RE: US 181 Harbor Bridge Replacement Project
CSJ# 0101-06-095
Notice of Developer Default

EXHIBIT A
SUMMARY OF SELECTED IBT FINDINGS AND CDA PROVISIONS²

INDEPENDENT STRUCTURAL ANALYSIS FOR THE CORPUS CHRISTI NEW HARBOR BRIDGE PROJECT

TOWER DRILLED SHAFTS

Figure 1: Foundation Cap 1NT, Foundation Cap and Shaft Layout, Drawing NHB-30A (by Others)

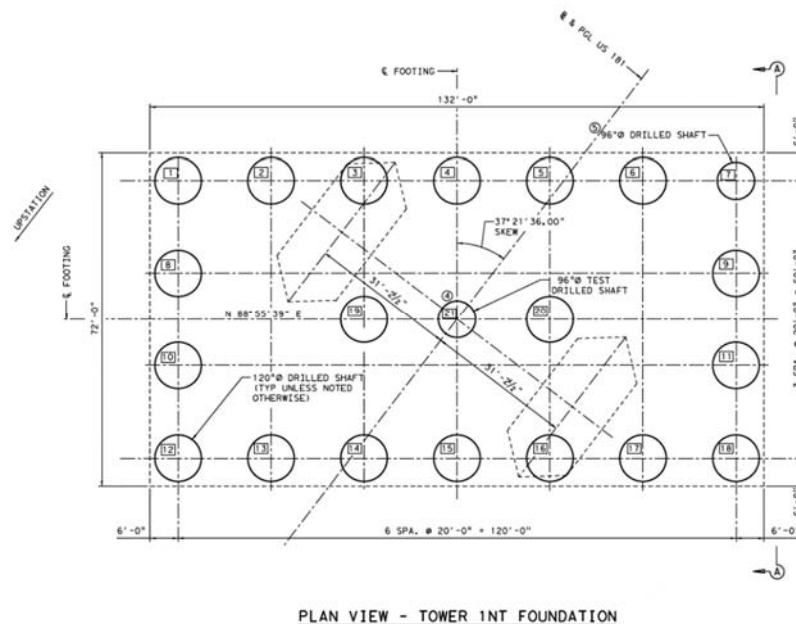
This technical memorandum discusses previously reported findings of the Independent Structural Analysis (ISA) group concerning the drilled shafts of the main tower foundations of the Corpus Christi New Harbor Bridge, cable-stay main bridge. The information presented herein demonstrates that the current design of the tower drilled shafts do not meet the project requirements for resisting axial forces subject to Strength limit state demands. These findings show an exceptional amount of concurrent overloading at multiple drilled shafts within the same foundation cap.

The Developer's Lead Engineer (DLE) has presented an alternate approach to evaluate the main tower drilled shafts, which assumes a rigid foundation cap and plastic deformation of the drilled shafts. The ISA has determined these assumptions are not appropriate for a foundation of this arrangement, size, loading, and complexity, which consequently leads to a significant underestimation of the actual loads on the drilled shafts.

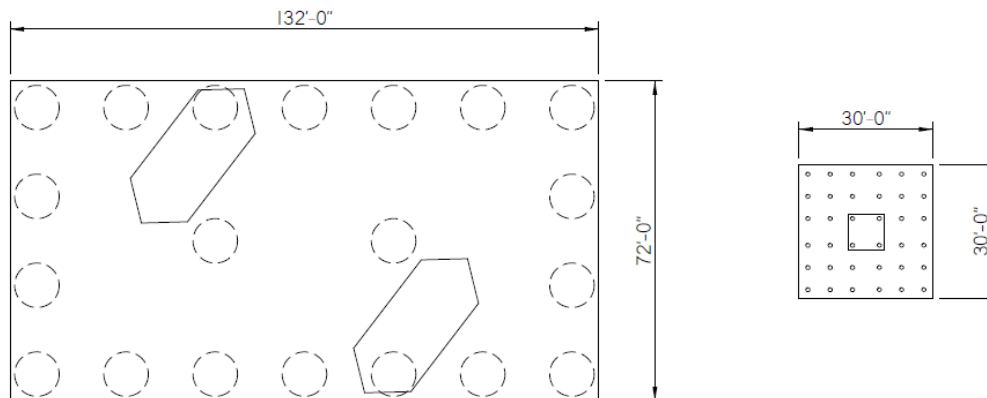
- The assumption of a rigid cap is contrary to the actual behavior of the cap. The analysis models clearly show that the cap has significant flexibility resulting in a load distribution to the drilled shafts that is not accurately captured by rigid cap modeling.
- The use of multiple analysis modeling assumptions decouples the analytical accuracy. In order to use detailed stand-alone models for specific structural elements (e.g. foundations), it is important that there is consistency with the assumed stiffnesses of the global model foundations.
- To choose the most favorable results from multiple models (rigid cap, flexible cap, or non-linear cap) is not accepted practice in engineering. The use of multiple modeling

assumptions to envelope potentially uncertain behavior is acceptable; however, every element of the structure must be shown to have adequate capacity for the results of each model.

Figure 1: Foundation Cap 1ST, Bottom Mat Reinforcement – Drilled Shaft Layout Schematic Provided by Others

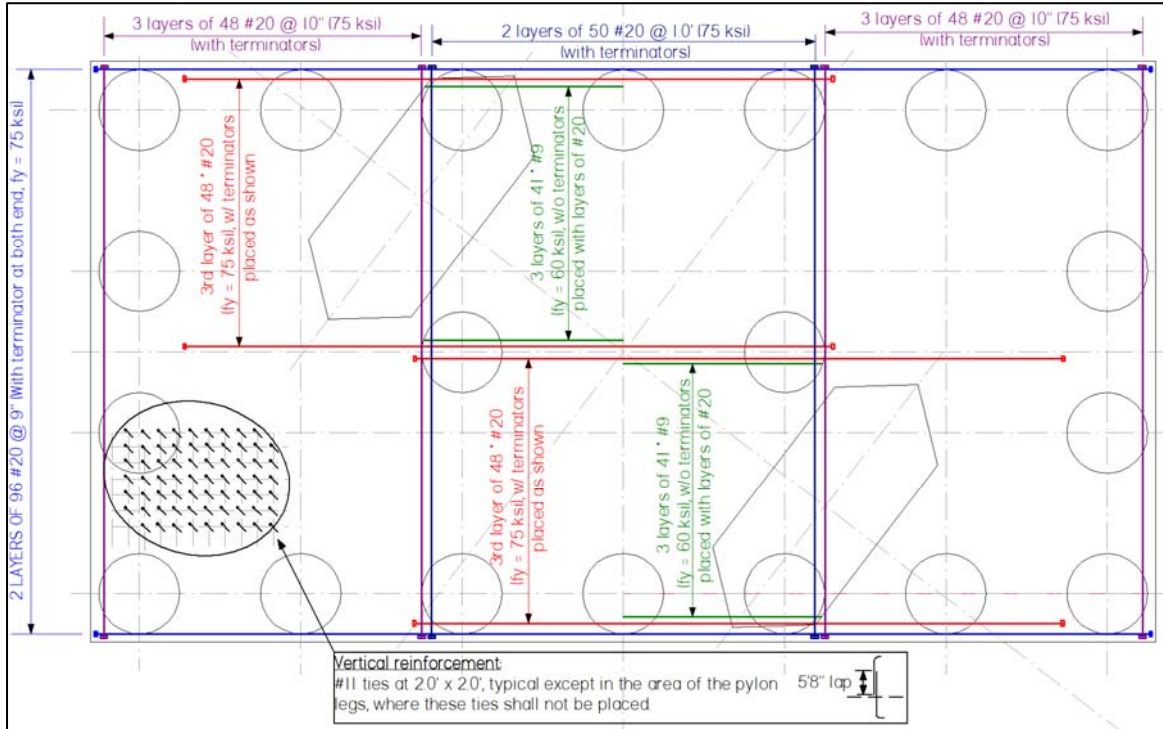
Some of these issues were raised in TxDOT/HNTB Review Comments (see Reference 9). For example, in Comment ID#38 TxDOT/HNTB comments that the Designer must consider punching shear of the tower legs. However, the Designer responded to that comment stating that punching shear of the tower does not govern the design. Also, the strut-and-tie method suggested in ID#20 would have revealed (as it did for the ISA team) that an adequate load path for the foundation cap does not exist for Strength limit state design loads that maximize compression at the “toes” of the tower legs, which are located too closely to the edge of the cap.

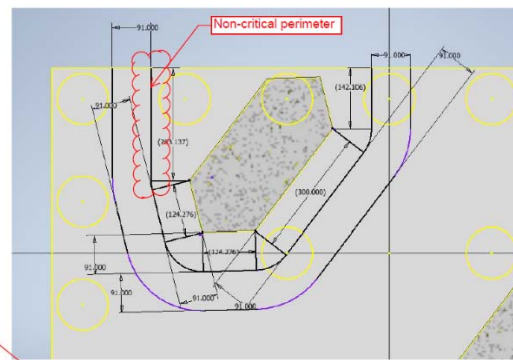
- b. The contribution of the drilled shafts shown in the DLE calculation is incorrect per AASHTO. Per AASHTO LRFD § 5.13.3.6.1, “Where a portion of a pile lies inside the critical section, the pile load shall be considered to be uniformly distributed across the width or diameter of the pile, and the portion of the load outside the critical section shall be included in the calculation of shear on the critical section.” The contribution from the drilled computed by the DLE shown in the figure below is significantly overestimated.

Any inclusion of the drilled shaft within d_v is unconservative, and the shaft contribution shall only include that portion within $d_v/2$ per AASHTO LRFD § 5.13.3.6.1. The DLE shows approximately 2.5 shafts within this unconservative perimeter giving a pile resistance of $2.5 * 15,400 \text{ kips} = 38,500 \text{ kips}$, versus the 55,046 kips presented in the table above. This results in a shear capacity of $\phi V_n = 63,315 + 38,500 - 2,943 = 98,872 \text{ kips}$. From DLE's foundations loads, $V_u = 111,900 \text{ kips}$, and therefore the **D/C is 1.13** does not meet AASHTO LRFD.

Figure 4: Critical Section Definition for Bending (Σ_2), One-Way Action (Σ_1') and Two-Way Action (Perimeter b_o)

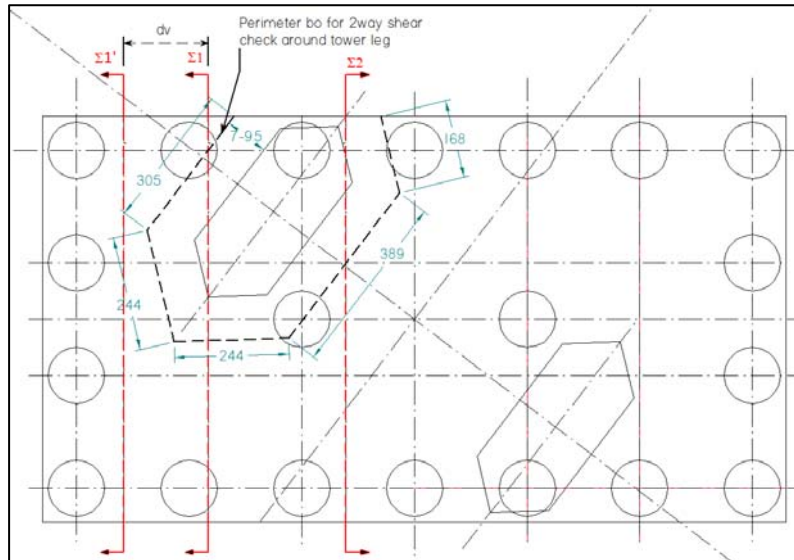
Per AASHTO LRFD § 5.13.3.6.1 and § 5.8.3.2, the critical section for one-way action extends across the entire width of the element and is located at a distance d_v from the face of the pier, with d_v being the effective shear depth of the section, which is $d_v = 187$ in for this foundation cap. The critical section for one-way action is shown as Σ_1' in the Figure 4 below.

Per AASHTO LRFD § 5.13.3.6.1, the critical section for two-way action around each pylon leg is perpendicular to the plane of the slab and located so that its perimeter, b_o , is a minimum but not closer than $0.5d_v$ to the perimeter of the pylon leg, as shown in the Figure 4 below.

Per AASHTO LRFD § 5.13.3.4, the critical sections for bending in footings is taken at the face of the pier. The critical section for bending is shown as Σ_1 and Σ_2 in the Figure 4 below.

Figure 8: Insufficient Development of Bar F0901 Past Section Σ2, per AASHTO LRFD §5.8.3.5

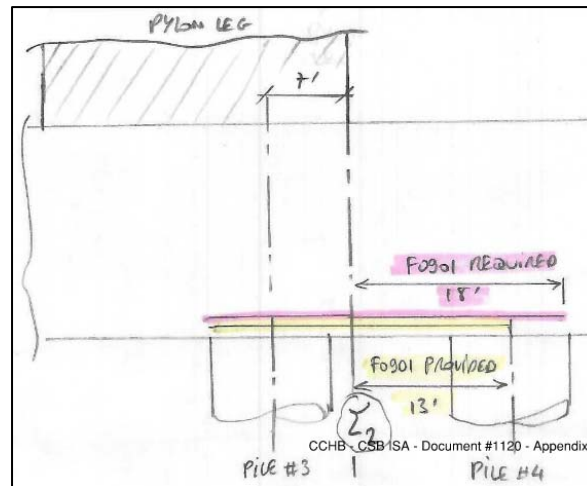
As shown in the Figure 6, the bending demand is concentrated on the side of the section closest to the pier leg carrying the maximum axial load. An attempt to address this concentration of the bending demand has been considered in the design, as evidenced by the local increase of bending reinforcement provided in this area: refer to Figure 1, where 3 layers of 41 #9 bars [bar marks F0901 on drawing NHB 55] are provided at this $\frac{1}{2}$ section. Although the axial + bending demand capacity ratio over the full section is adequate, the ISA team estimates that given the dimension of the foundation cap and the localized nature of the demand, the local reinforcement must be sized to adequately resist the localized demand over a $\frac{1}{2}$ section. With the reinforcement provided, the bending demand exceeds the capacity with a demand-to-capacity ratio, D/C = 1.25, as shown in the interaction plot in Figure 7. Also, bars F0901 should be extended by an additional 5' past section $\Sigma 2$ to be fully developed, per AASHTO LRFD §5.11.2 and §5.8.3.5. (see Figure 8).

Figure 10: Shear Stress Distribution Along Plane AB for ISA Governing STR III Load Combination

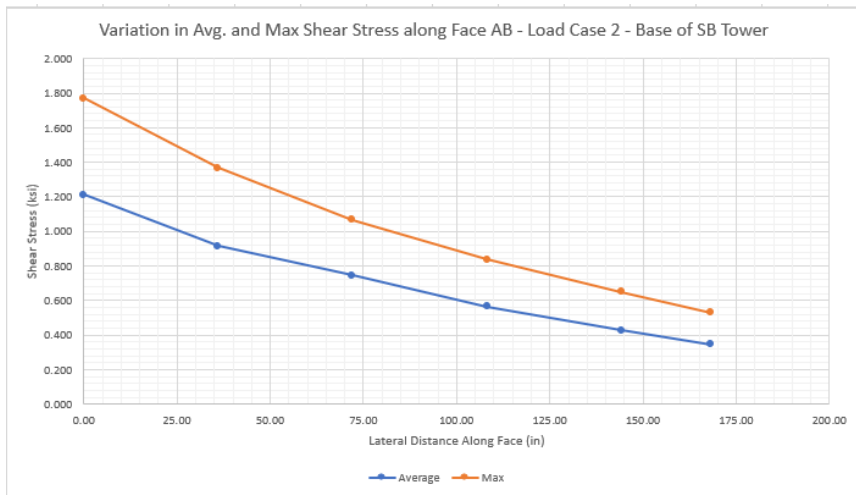
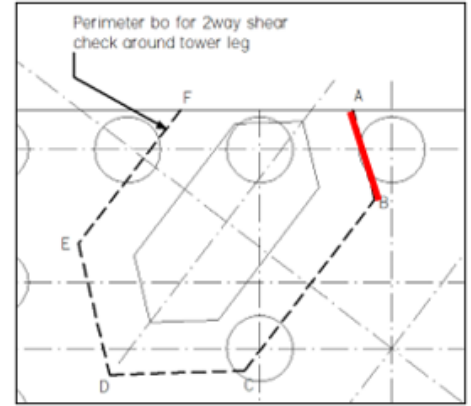
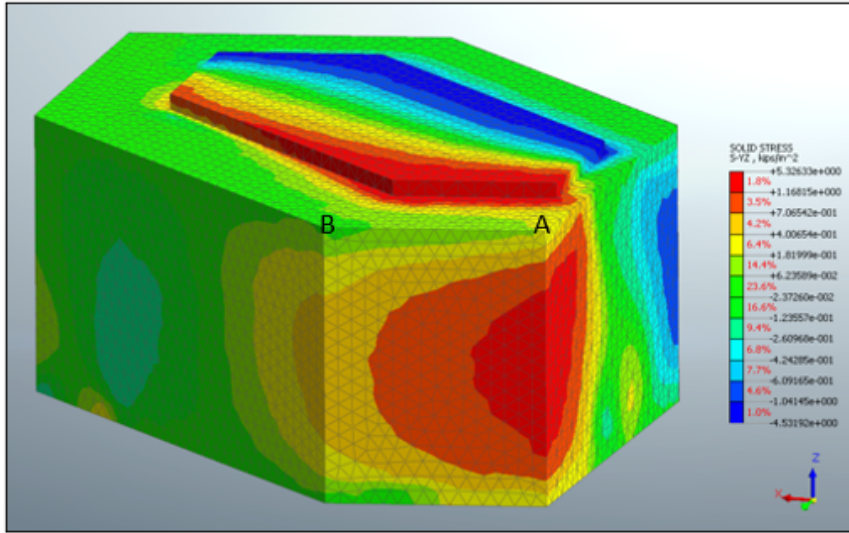
The average shear stress demand under Strength III in the area AB shown in Figure 10 varies between $v_u = 1.2$ ksi at node A and $v_u = 0.4$ ksi at node B, which can be compared to the shear stress capacity evaluated in Appendix B3 above for the perimeter b_o : $vr = V_r / (b_o \cdot d_v) = 70,596 \text{ kip} / (1,350 \text{ in} * 187 \text{ in}) = 0.28 \text{ ksi}$.

The maximum factored shear (averaged through the depth of the section) from the brick-element finite element model shown in Figure 10 is 1.2 ksi. This agrees with results from plate element models described herein and with the models discussed in the ISA Phase 1 Report and the ISA Phase 2 Part 1 Report. Regardless of the amount of reinforcement provided, both AASHTO LRFD and ACI-318 limit the maximum factored allowable shear. AASHTO LRFD and ACI limits shear to $\phi 0.192 \sqrt{f'_c}$. With $f'_c = 5.5$ ksi, this results in an allowable shear stress of 0.40 ksi compared to the demand of 1.2 ksi noted above.

Therefore, even if the maximum amount of shear reinforcement was provided (and it was not), the foundation cap section, as currently designed, cannot resist the design loading considered. The foundation cap needs to be thicker, or the tower legs need to be located further away from the edges, or the tower loads need to decrease, or some combination thereof.

Figure 12: Shear Stress Distribution Along Plane EF of Perimeter bo for ISA Governing STR III Load Combination

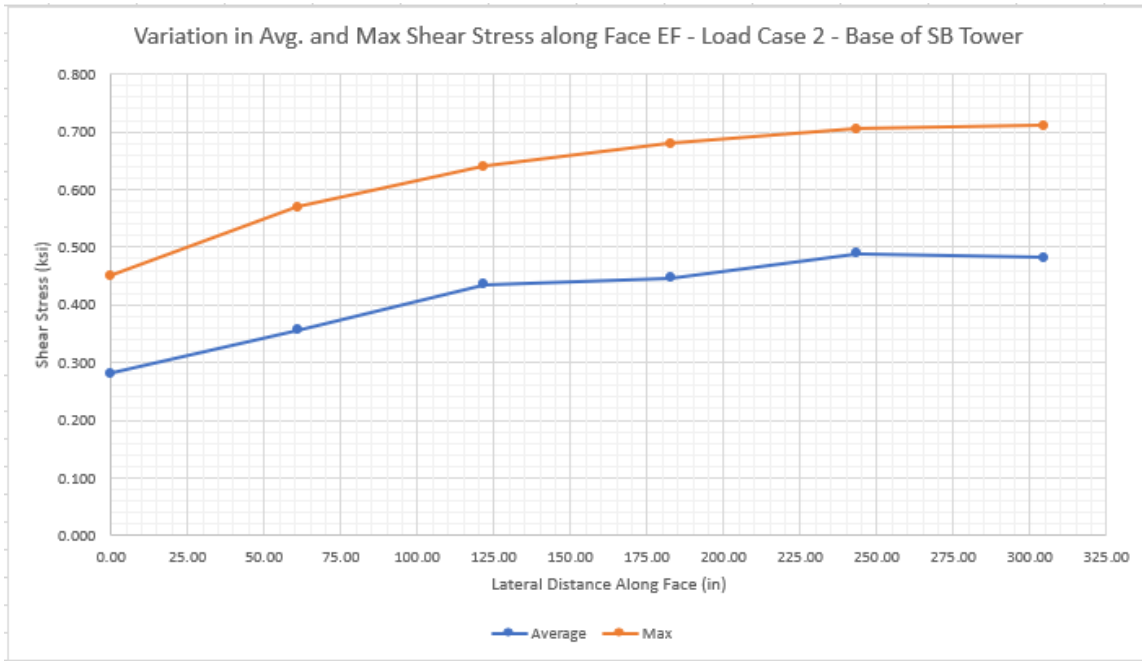
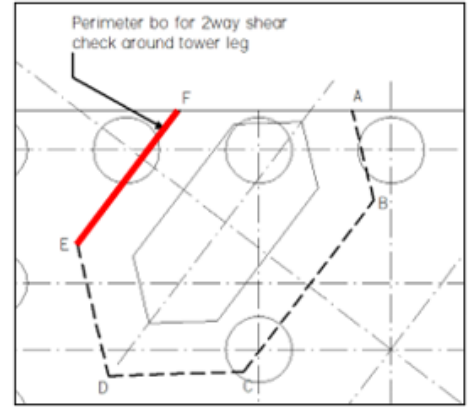
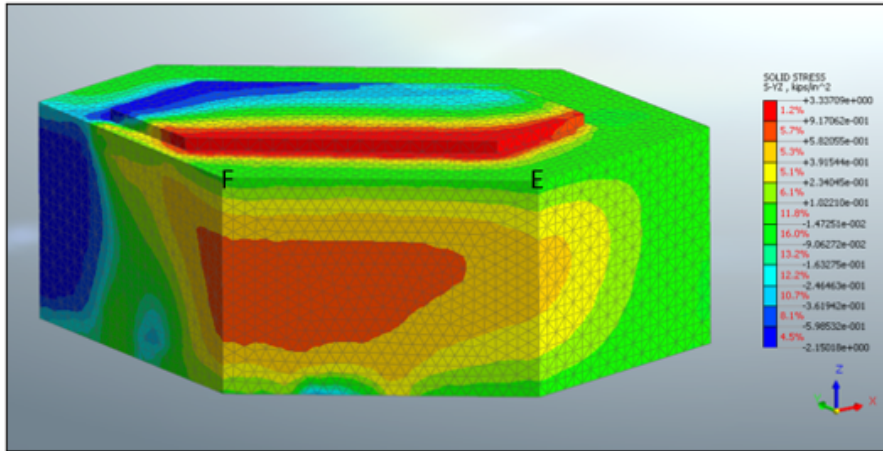
Similarly, the average factored shear stress demand under Strength III in the area EF shown in Figure 12 varies between $v_u = 0.28$ ksi at node E and $v_u = 0.48$ ksi at node F.

Figure 1: Delta Frame – To- Box Girder Connection (NB Shown, SB Similar)

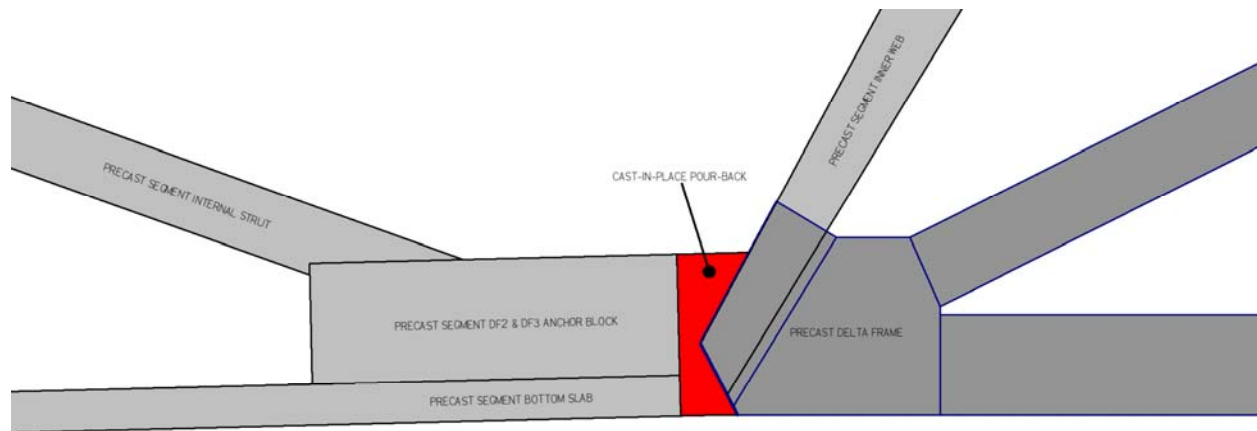
This technical memorandum discusses previously reported findings of the Independent Structural Analysis (ISA) concerning the delta frame – to – box girder connections of the Corpus Christi New Harbor Bridge, cable-stayed main bridge, where the current design does not meet the project requirements. This and several other findings related to the delta frames have been documented in previous reports (see References 3. and 4. below) and discussed in meetings (see References 6., 7., and 8. below). These findings have yet to be resolved by the Developer, and they have not been addressed by changes in wind input recently observed in the updated (Rev. 2) Wind Report (see Reference 5. below). This technical memorandum focuses solely on the findings related to the delta frame – to – box girder connection design, as shown in Figure 1 below.

Figure 2: Delta Frame Tendon DT2 & DT3 Anchor Block Details (NB Shown, SB Similar) – Schematics by Others

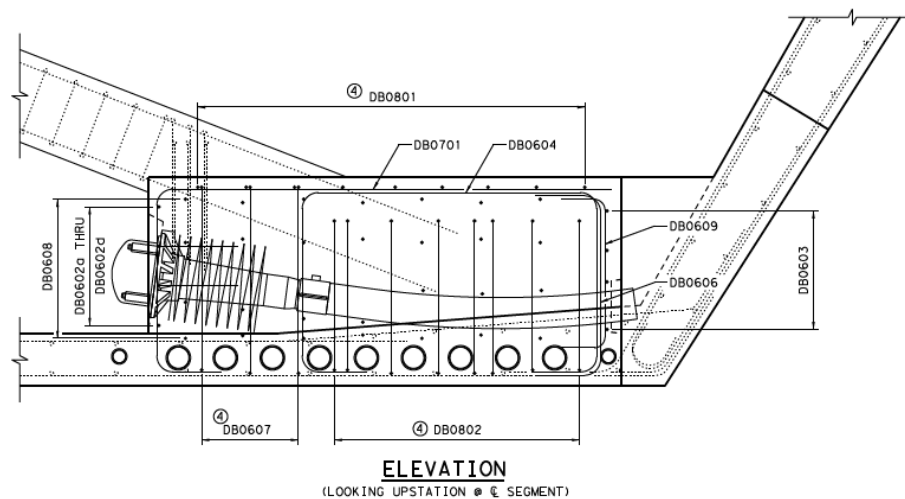
AASHTO LRFD §5.8.4.1 requires, “The minimum area of interface shear reinforcement specified in Article 5.8.4.4 shall be satisfied.” In the current design as shown in Figure 2 below, there has been no interface reinforcement provided across the interfaces between the cast-in-place pour-back and the bottom precast segment DF2 & DF3 anchor block nor between the pour-back and the precast delta frame. This does not meet the requirements of AASHTO LRFD §5.8.4.1 and §5.8.4.4.

These unreinforced interfaces, which must be able to transfer axial load, shear, and flexure from the box girders to the delta frames, lack a ductile means to adequately resist flexure and shear at this critical connection. The DF2 and DF3 post-tensioning tendons cross two of these interfaces. However, AASHTO LRFD §5.8.4.1 does not include post-tensioning as an acceptable means to resist interface shear. Further, literature cited in the AASHTO LRFD Commentary and other relevant literature lack experimental research to support the sole use of post-tensioning to provide ductile interface shear resistance without interface reinforcement allowed by AASHTO LRFD §5.8.4.1: single bars, multiple leg stirrups, or welded wire fabric.

Figure 2: Delta Frame Tendon DT2 & DT3 Anchor Block Details (SB Shown, NB Similar) – Schematics by Others

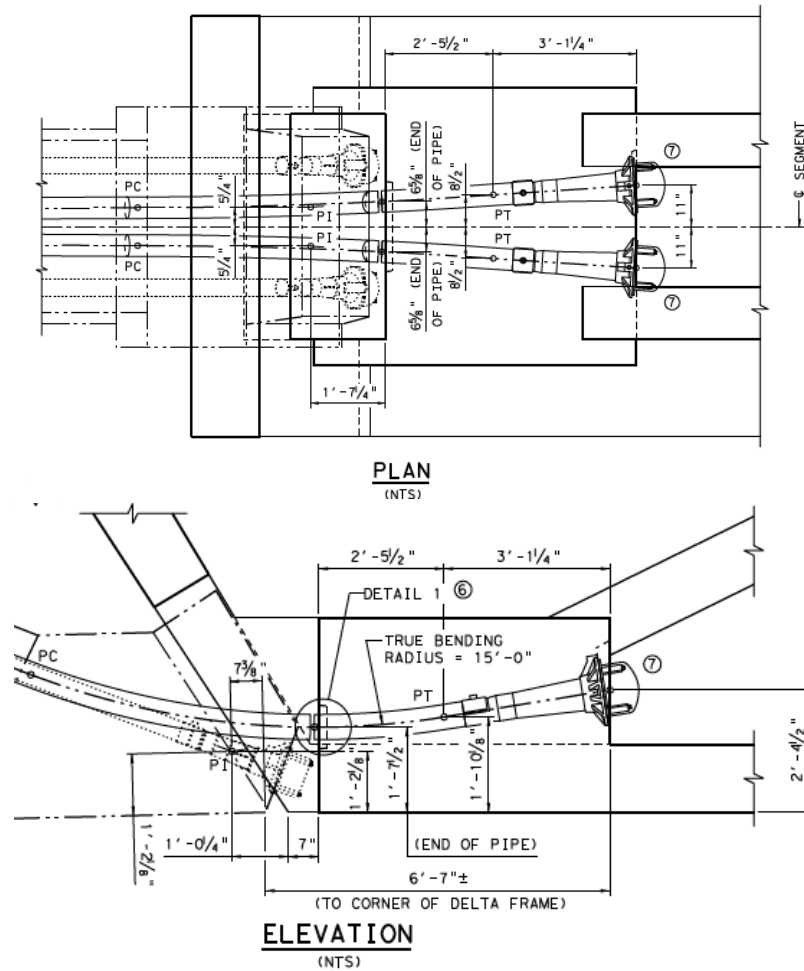
The unreinforced pour-back also does not meet some of the requirements of AASHTO LRFD §5.10 – Details of Reinforcement (e.g., minimum reinforcement spacing requirements, temperature and shrinkage requirements, effects of curved tendons, etc.). Referring to Figure 2 below, the pour-backs must resist radial stresses from the 2 x 31-strand tendons that deviate through this element with a 15' radius. Without reinforcement, the pour-back does not have a means to meet the requirements of AASHTO LRFD §5.10.4.3.

Figure 1: Stage 12 S1 Stressing Showing Erection Phase and Critical Section Investigated

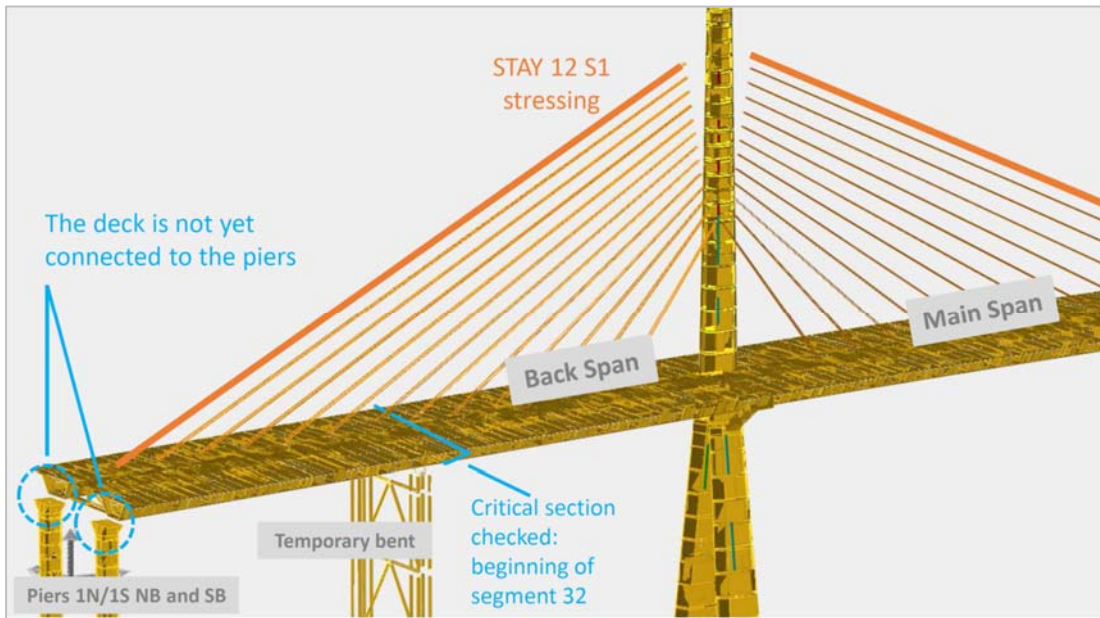
The current design of the bottom slab of the back span superstructure has insufficient post-tensioning to provide the flexural resistance necessary to withstand positive bending (tension at the bottom) caused by wind and other effects at a certain stage of construction. The state of the structure considered is

shown in Figure 1 below. The loading considered occurs after the first-stage stressing of the Stay 12 pair of stays, just before the superstructure reaches the back span piers 1N and 1S.

Figure 2: Elevation View Showing Critical Section Investigated (NB shown – SB similar)

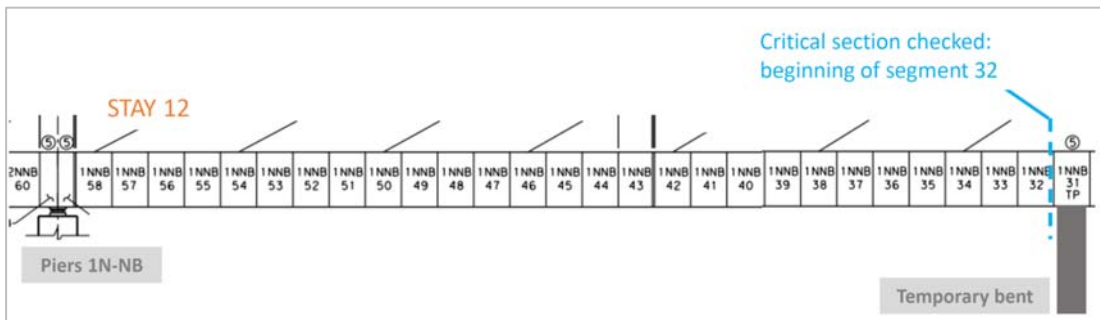
The critical sections are located at the beginning of NB and SB segments 32. These segments are the first ones erected after the temporary bent has been connected to the deck.

At this phase of construction, these segments experience large positive bending moment (tension at the bottom) due to the first stage stressing and due to the factored wind demand for that configuration, identified as BLWTL’s Wind Case 2 (originally named “Construction Case #2, free cantilever, before arrival to the back span pier (temporary pier still active), for West wind direction”) with only five post-tensioning bars located in the bottom slab to provide resistance.
